World Forum for Harmonization of Vehicle Regulations

Proposal for Supplement 9 to the 03 series of amendments to UN Regulation No. 129 (Enhanced Child Restraint systems)

Submitted by the Working Party on Passive Safety *

Figure 4
Arrangement for Testing a Forward-Facing Device

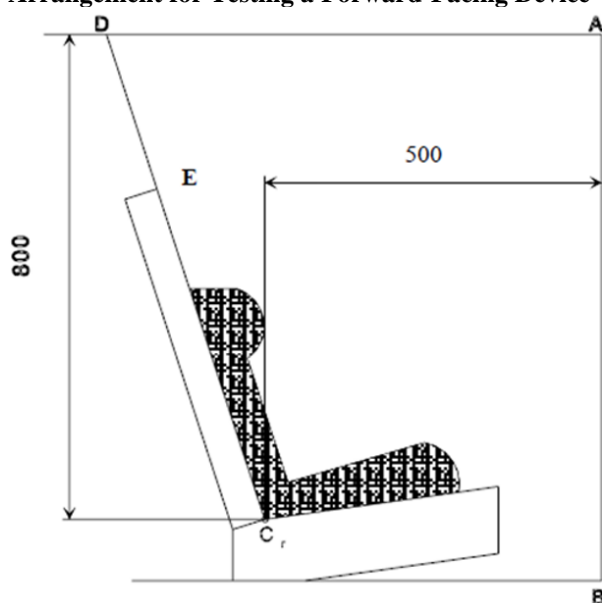
Paragraph 6.6.4.1.1., amend to read:

"6.6.4.1.1. Forward-facing Enhanced Child Restraint Systems

Integral Enhanced Child Restraints: No part of the head of the dummy shall pass beyond the planes BA, DA and DE as defined in Figure 4 below:

- (a) The value in relation to the BA plane is 500 mm; and
- (b) The value in relation to the DA plane is 800 mm, except when testing with the Q3 or Q6 dummy where the value is 840 mm; and
- (c) However, the head of the dummy may pass beyond the DE plane, if the head pad or the backrest part of the child restraint structure, which is behind the head of the dummy, at the point the head, passes the DE plane; and
- (d) In case of dummy contact with a rigid part of the test bench in the rebound phase, the head acceleration criterion during that contact shall not be considered.

Non-integral booster seat: No part of the head of the dummy shall pass beyond the planes BA and DA as defined in Figure 4 below.

- (a) The value in relation to the BA plane is 550 mm; and
- (b) The value in relation to the DA plane is 840 mm; and
- (c) The rebound phase is not considered for the assessment of the plane DA.

- (a) The value in relation to the BA plane is 550 mm; and
- (b) The value in relation to the DA plane is 840 mm; and
- (c) The rebound phase is not considered for the assessment of the plane DA; and
- (d) In case of dummy contact with a rigid part of the test bench in the rebound phase, the head acceleration criterion during that contact shall not be considered.

6.6.4.4.1.1.1. Where a test is conducted in accordance with paragraph 6.6.4.1.6.1.1. or paragraph 6.6.4.1.6.1.2. or paragraph 6.6.4.1.8.2. above, a tolerance of +10 per cent shall be applicable to the head excursion value distance between the Cr point and plane AB.

"Figure 1

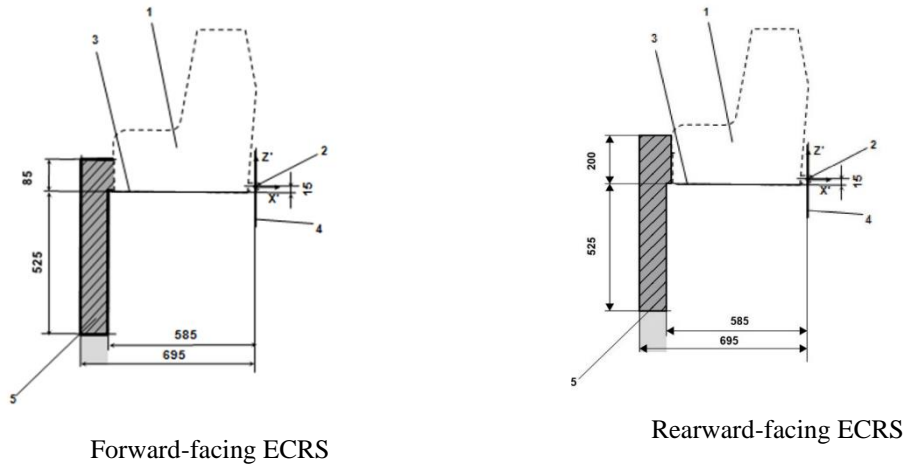
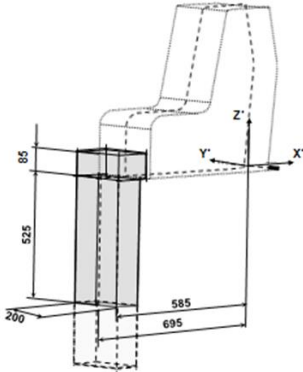
Annex 19., Figure 1, amend to read:

Side view of the support leg dimension assessment volume

1. Enhanced Child Restraint Fixture (ECRF).
2. ISOFIX low anchorages bar.
3. Plane formed by the bottom surface of the ECRF, which is parallel to and 15 mm below the X'-Y' plane of the coordinate system.
4. Z'-Y' plane of the coordinate system.
5. Upper part of the support-leg dimension assessment volume, which shows the dimensional limitations in X' and Y' direction, the upper height limit in Z' direction, as well as the lower height limitation in Z' direction for rigid, not in Z' direction adjustable support leg components.

"Figure 2
3D view of the support leg dimension assessment volume

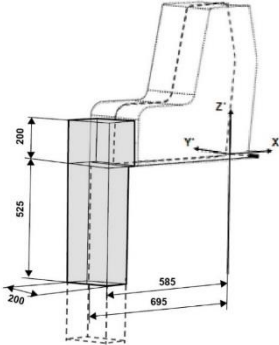
Annex 19, Figure 2, amend to read:
